FINAL
ENVIRONMENTAL IMPACT STATEMENT
USDA-SCS-ES-WS-(ADM)-74-13-(F)
**LEONA RIVER WATERSHED
PROJECT**
Uvalde County, Texas

LEONA RIVER WATERSHED
UVALDE COUNTY, TEXAS

FINAL ENVIRONMENTAL IMPACT STATEMENT

Figure 1

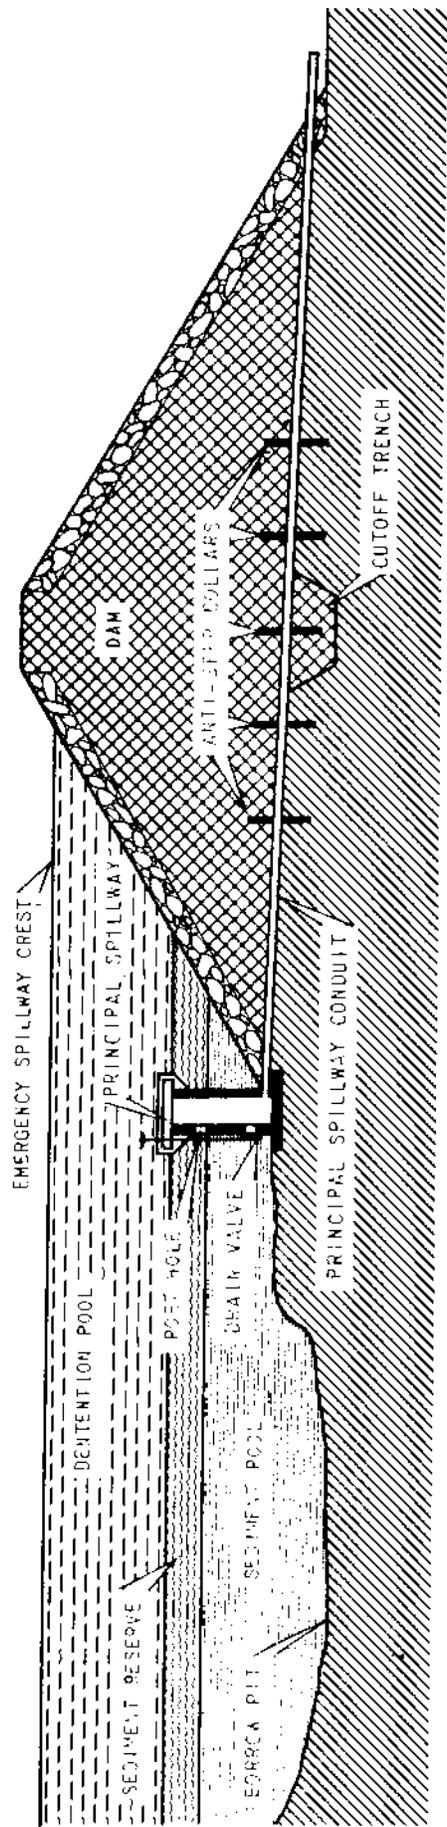
- Comment:** The Department stated, "The project description as now presented is only partially adequate because it does not fully describe what structural measures will be built. The fourth paragraph on page 15 (of the draft environmental statement) obliquely refers to embankments, but it would be better to fully describe the embankments in the second paragraph. Also, figures 2 and 3 from the work plan might be added to the environmental statement to enhance the project map in Appendix C."

- Response:** The narrative in the PLANNED PROJECT section has been revised and additional information added to describe more precisely the structural measures to be constructed. A section of a typical floodwater retarding structure has been included in the Planned Project section as Figure 1.

Appendix C
 Figure 7
 PROJECT MAP
 LEONA RIVER WATERSHED
 UVALDE COUNTY, TEXAS
 U.S. DEPARTMENT OF AGRICULTURE
 SOIL CONSERVATION SERVICE
 TEMPLE, TEXAS

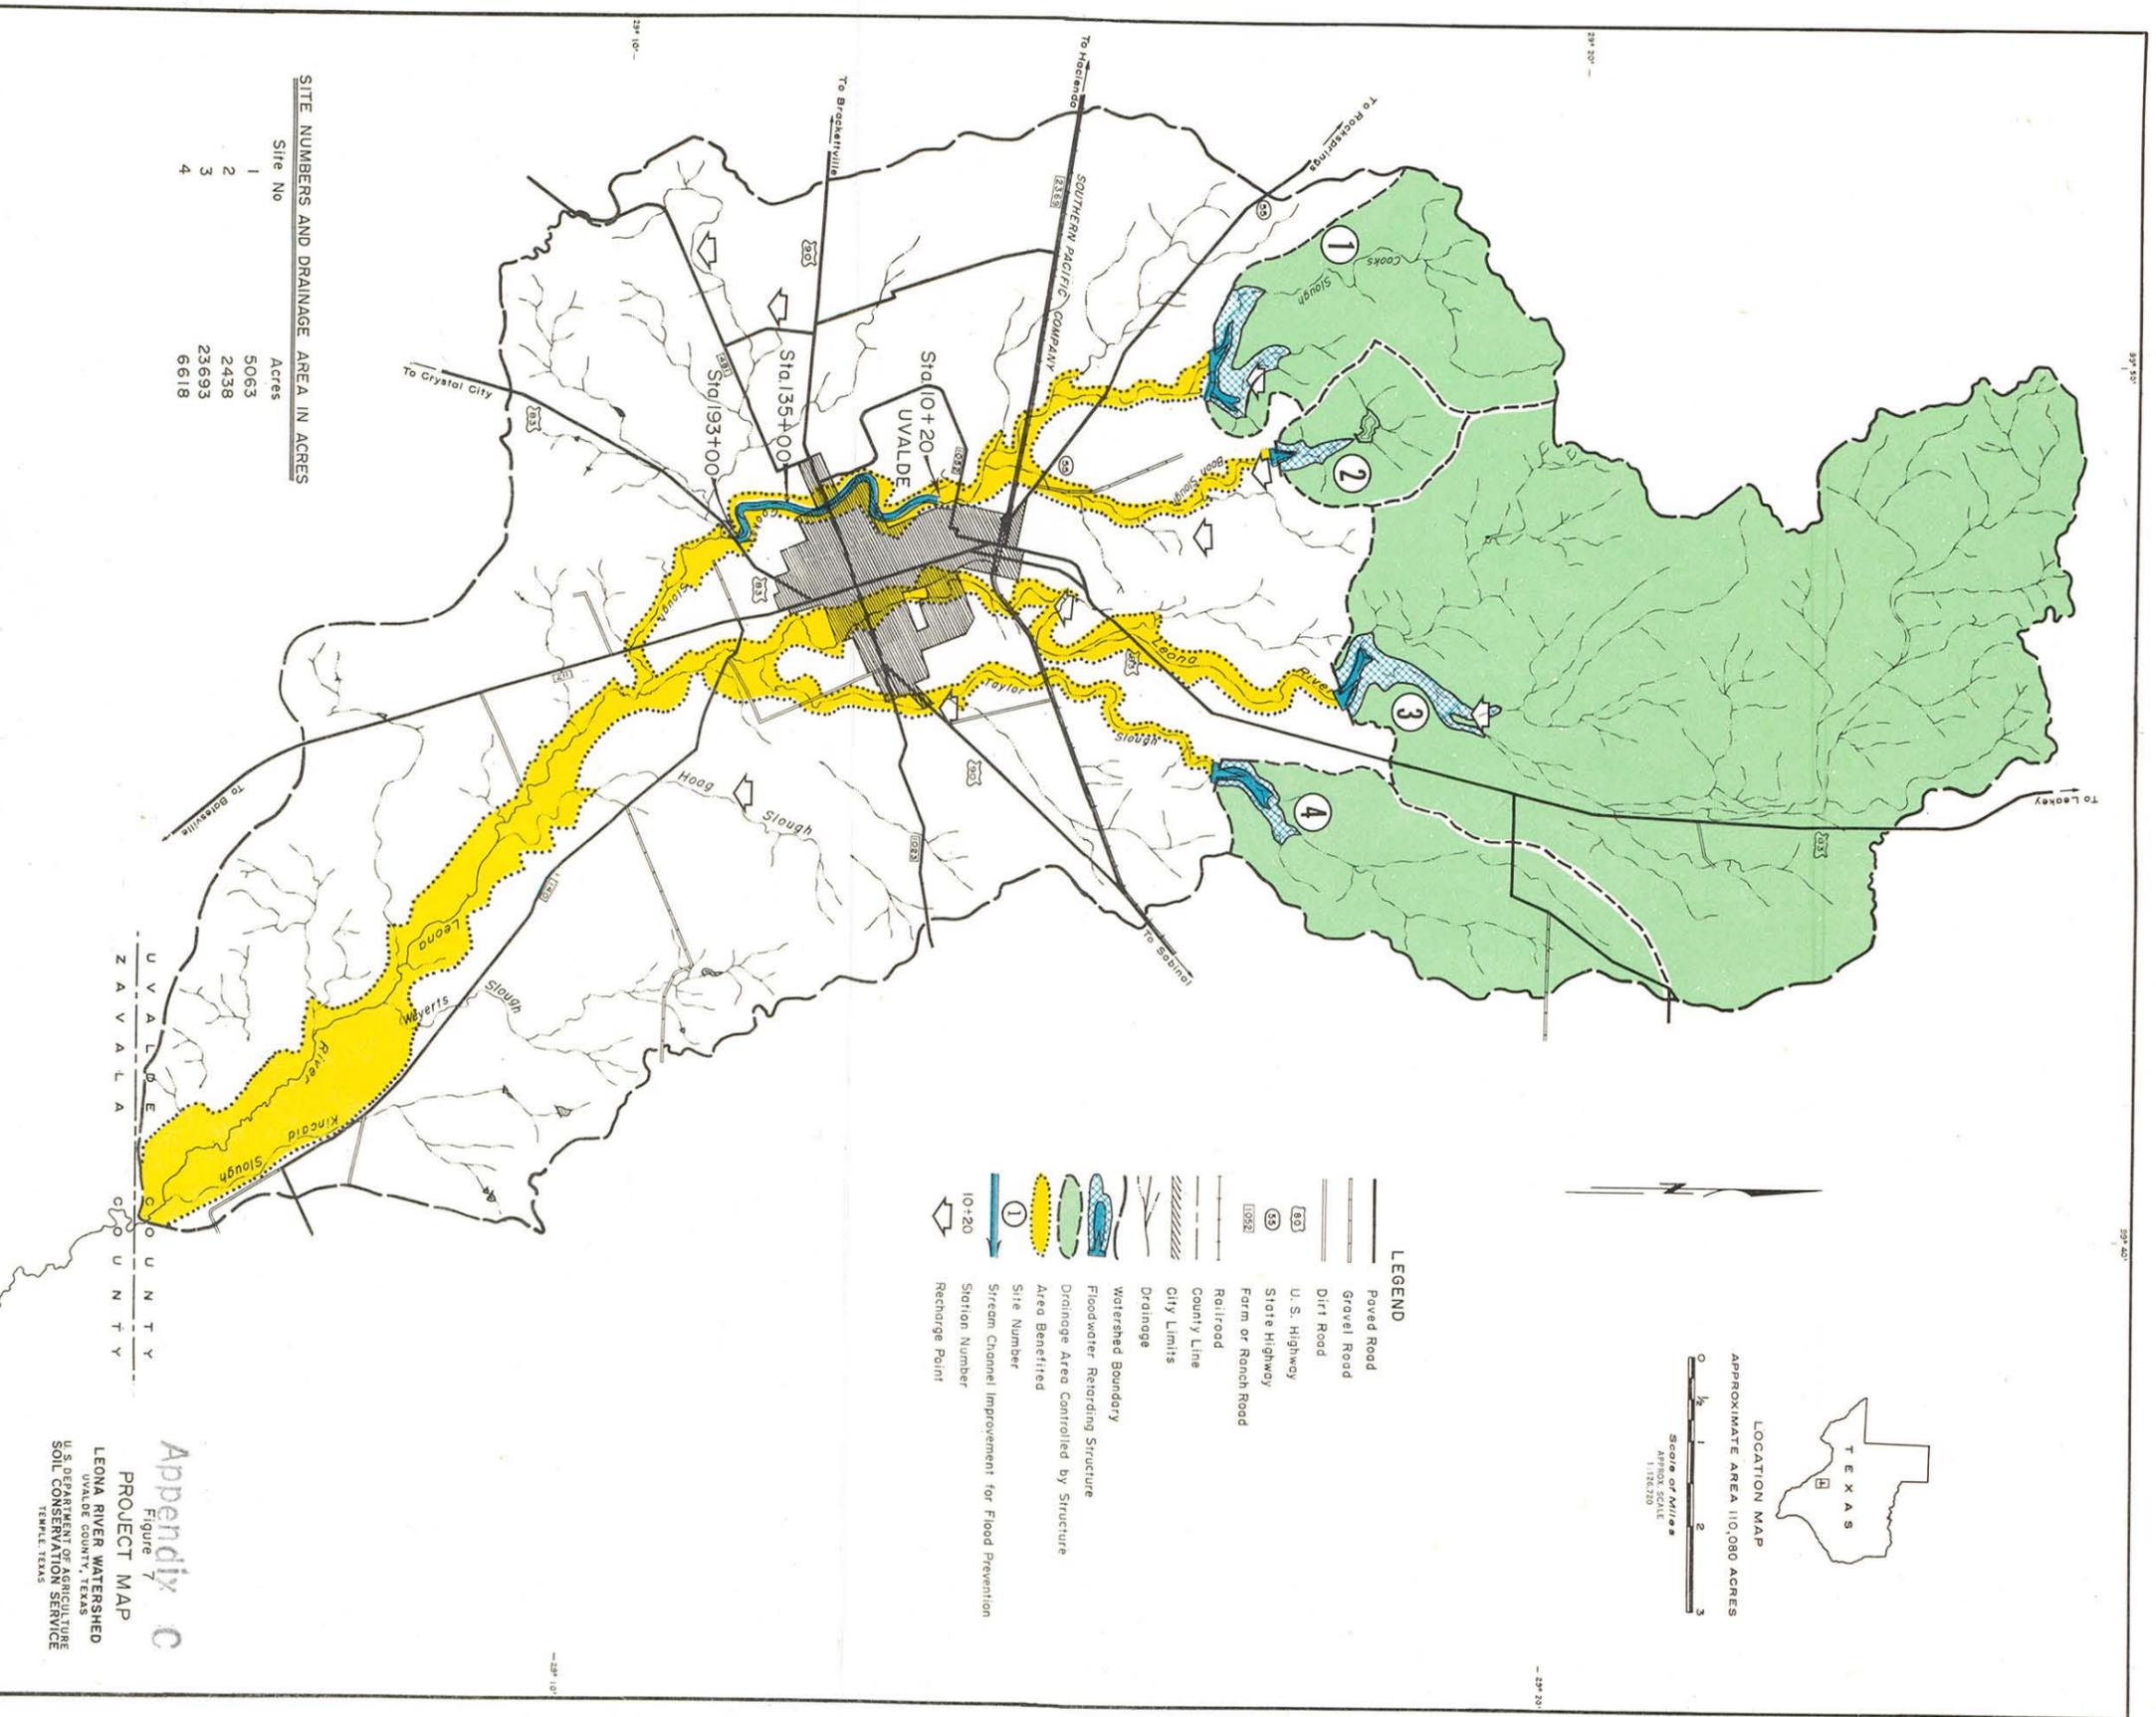
It should be more clearly stated in the work plan that the proposal covers only a portion of the Leona River Watershed. A reviewer must rely on the Project Map (Figure 7) to establish an overview of the various project segments. Regarding the channel improvement along Cooks Slough, there appears to be no provision for
